**Millstone Power Station Unit 2 GSI-191 Generic Letter 2004-02
Corrective Actions Audit Report**

Figure 3.6.1.3.2-1 Walnut Shell Flour Particle Size Distribution

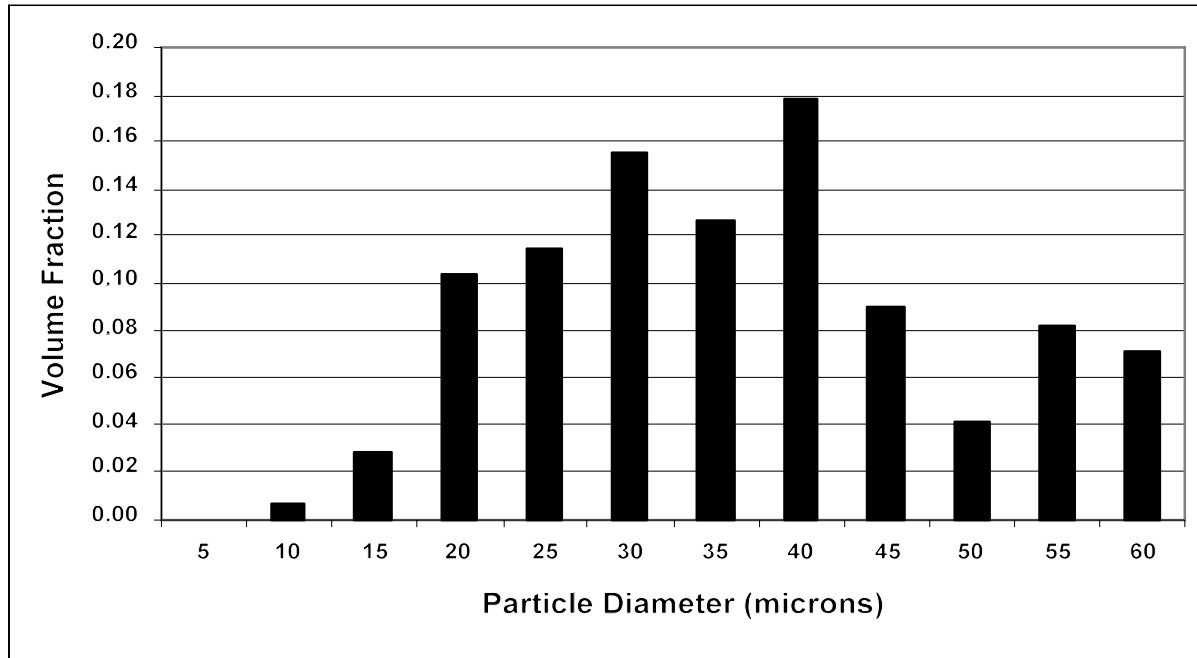
With regard to the head loss characteristics of the walnut flour, the only information provided directly to the NRC staff was a particle size distribution obtained from the manufacturer. This size distribution, which is converted to volume fractions, is shown in Figure 3.6.1.3.2-1 below [125]. A detailed comparison of the walnut flour with coatings particulate was not available for review. The AECL analysis [page 5-3 of 124] of the walnut particle size distribution determined that the average size was about 23 µm, and (from a specific surface area consideration based on spherical particle shape assumption) the effective particle size was about 32 µm. This means that the walnut flour particles were a factor of about 3.2 larger than the GR recommendation, which translates to a factor of 10 decrease for head loss impact. Note that at the very low approach velocities associated with the Millstone replacement strainer, the head loss is approximately linear with the square of the specific surface area [123]. The specific surface area for the walnut flour size distribution, assuming spherical particles, is about 57,000

ft²/ft³, as compared to 183,000 ft²/ft³ for the SE-assumed particulate. Therefore, if only the walnut flour hydraulic characteristics are considered, a conclusion could be drawn that walnut flour may not be a good surrogate material to meet GR and SE coatings requirements.

Figure 3.6.1.3.2-2 Walnut Shell Flour Specific Surface Areas Experimentally Deduced by NRC Staff from Thin-Bed Tests

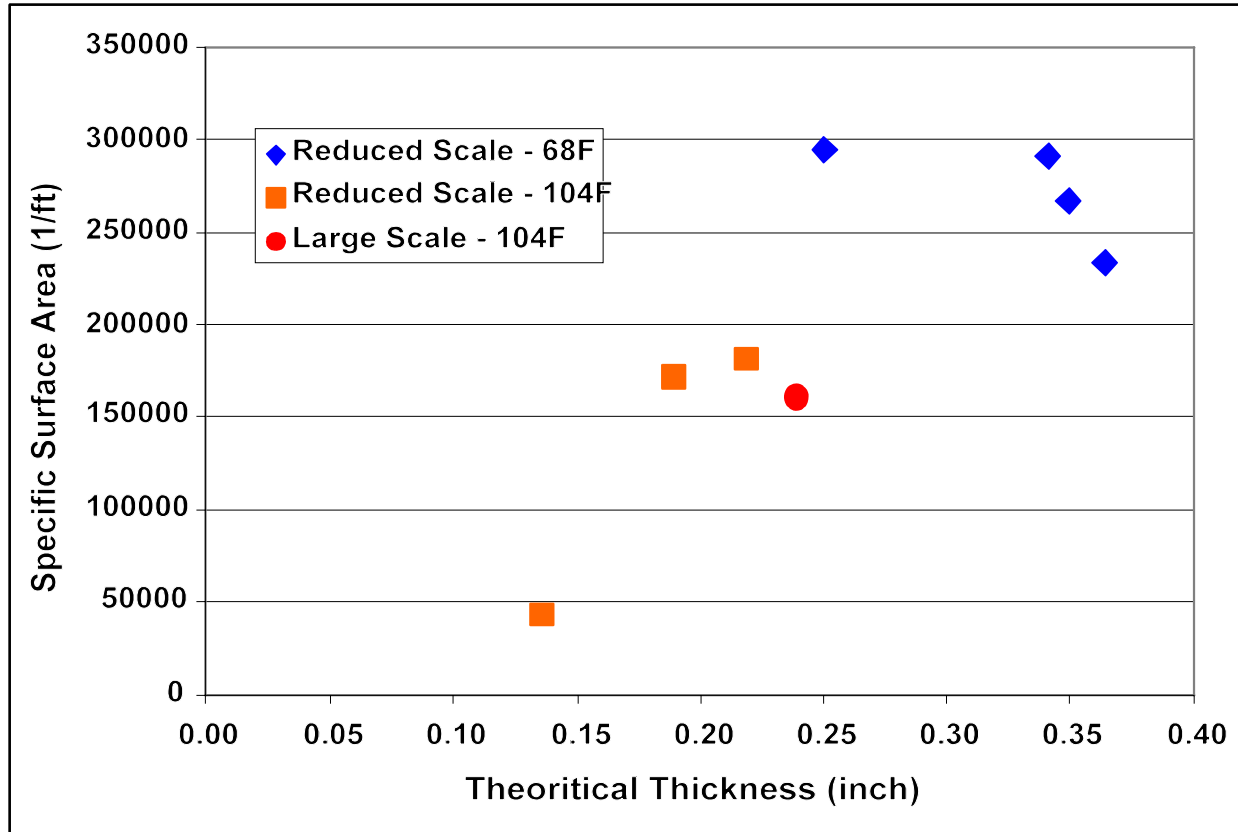
The following observations were made from Figure 3.6.1.3.2-2:

- The staff deduced specific-surface area values for walnut shell flour, which are shown in Figure 3.6.1.3.2-2. These values are close to that for hypothetical 10 μm spherical particles (183,000 ft^2/ft^3) found in the GR [1]. As demonstrated in [11], head loss characteristics are strongly correlated to specific surface area. Therefore, the experimental evidence strongly indicates that the head loss characteristics of the walnut shell flour are close to the GR-recommended 10 μm spherical particle, and may even be conservative with respect to the GR guidance.
